**RE: Ladera Self Storage  
Conceptual Grading and Drainage Plan  
Engineer's Stamp Date: 05/03/18  
Hydrology File: H09D001F**

Based upon the information provided in your submittal received 05/03/18, the Conceptual Grading and Drainage Plan is approved for action by the DRB for Preliminary Plat and Site Plan for Building Permit.

Project Title: Ladera Self Storage  
Tract B1 of Tracts A1 & B1, Mariposa Square Subdivision  
Albuquerque, NM 87120  
Drawing Title: Conceptual Grading and Drainage Plan

C.01

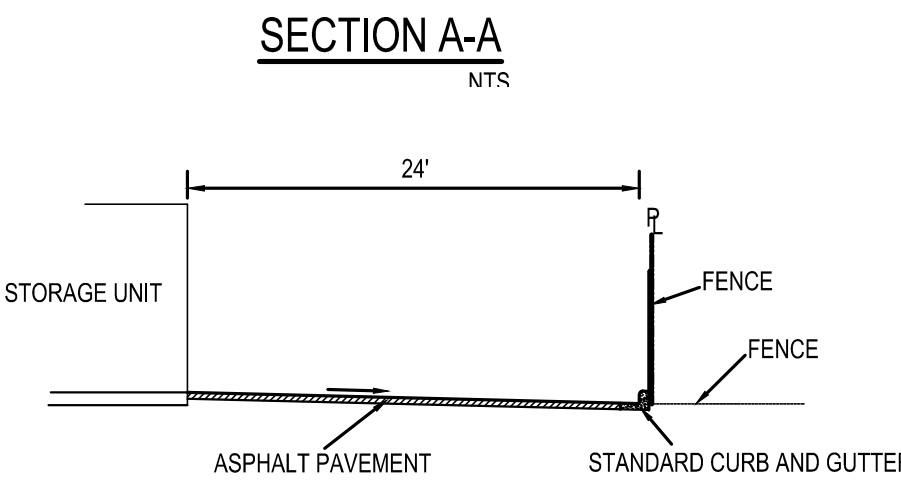
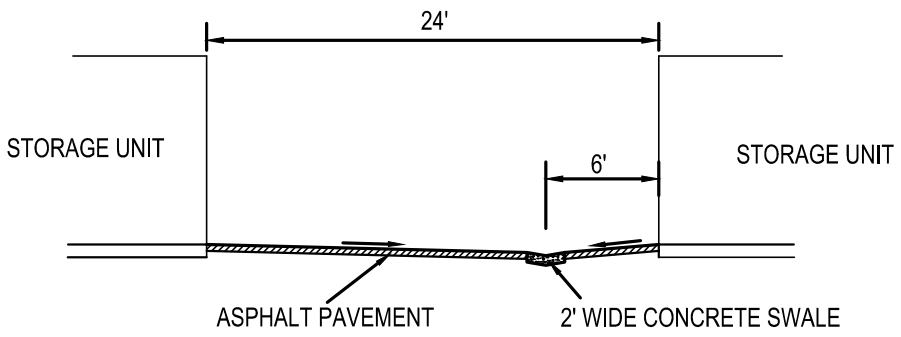
Your submittal **is not** approved for Building Permit and SO-19 Permit. The following comments need to be addressed for approval of the above referenced project:

1. Please provide the SO-19 Notes. I have attached them for your use.
2. Please provide weir calculations for 24" curb cuts, 24" sidewalk culvert, and 12" concrete channel.
3. Please change Key Note #4 from a 12" sidewalk culvert to a 12" concrete channel. This is not going under a sidewalk, so there will be no steel plate needed.
4. Please provide first flush calculations.
5. Please provide a typical cross section of the first flush pond to include the storage unit and the property line with dimensions. Also show if the ponds are to be gravel or just dirt.

Please provide a Private Facility Drainage Covenant per Chapter 17 of the DPM for first flush ponds prior to Certificate of Occupancy. Please submit this on the 4th floor of Plaza de Sol. A \$25 fee will be required.
